Access Compliance Report

Public Rights-of-Way

(Curb Ramps)

Intersection ID: 10038086	Main Street: SIKES_PL	Cross Street: N/A	Location: SW
ADA ID: FB11AE45B7E5	Ramp Type: Perp	Initial Pass/Fail: Fail	Overall Compliance: No
Severity Score: 13.75			
Codes/Mitigation Info/Possible Solution		Field Measurements/Component Compliance

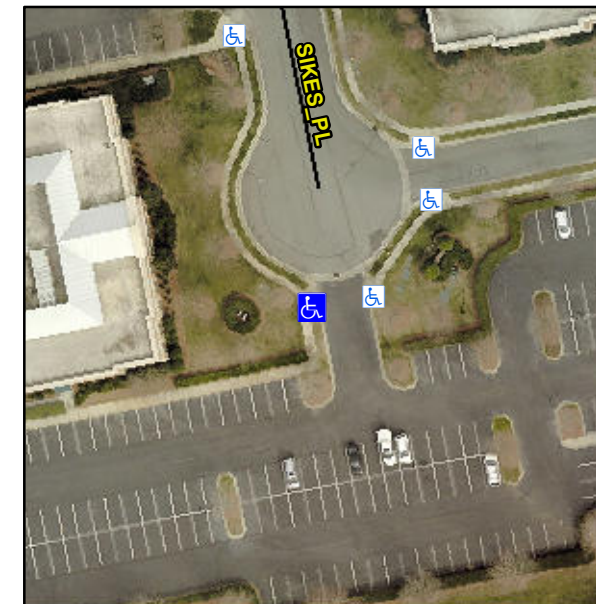
Not Found, R304.2.2, R304.5.3

Compliance	Description	Data	Compliance	Description	Data
N/A	Ramp Length (in)	62.0	No	Ramp Slope (%)	10.0
Yes	Ramp Width (in)	64.0	No	Ramp XSlope (%)	2.6
N/A	Flare Type LT	N/A	N/A	Flare Type RT	N/A
N/A	Flare Slope LT (%)	N/A	N/A	Flare Slope RT (%)	N/A
N/A	Flare Traversable LT?	N/A	N/A	Flare Traversable RT?	N/A
N/A	Landing Length (in)	N/A	N/A	DWS Provided?	N/A
N/A	Landing Width (in)	N/A	N/A	DWS Contrast?	N/A
N/A	Landing Slope (%)	N/A	N/A	DWS Length (in)	N/A
N/A	Landing X Slope (%)	N/A	N/A	DWS Full Width?	N/A
N/A	Landing Curb? (Y/N)	N/A	N/A	DWS Offset (in)	N/A
N/A	Shared Landing?	N/A			
N/A	Gutter Ponding?	N/A	N/A	Gutter Slope (%)	N/A
N/A	Gutter Lip Ht (in)	N/A	N/A	Gutter X Slope (%)	N/A
N/A	Painted X Walk1?	No	N/A	Painted X Walk2?	N/A
	X Walk 1 Direction	To E		X Walk 2 Direction	N/A
N/A	X Walk 1 Width (in)	N/A	N/A	X Walk 2 Width (in)	N/A
	X Walk 1 Slope (%)	1.5		X Walk 2 Slope (%)	N/A
	X Walk 1 X Slope (%)	1.2		X Walk 2 X Slope (%)	N/A

Remove & Replace Entire Ramp.
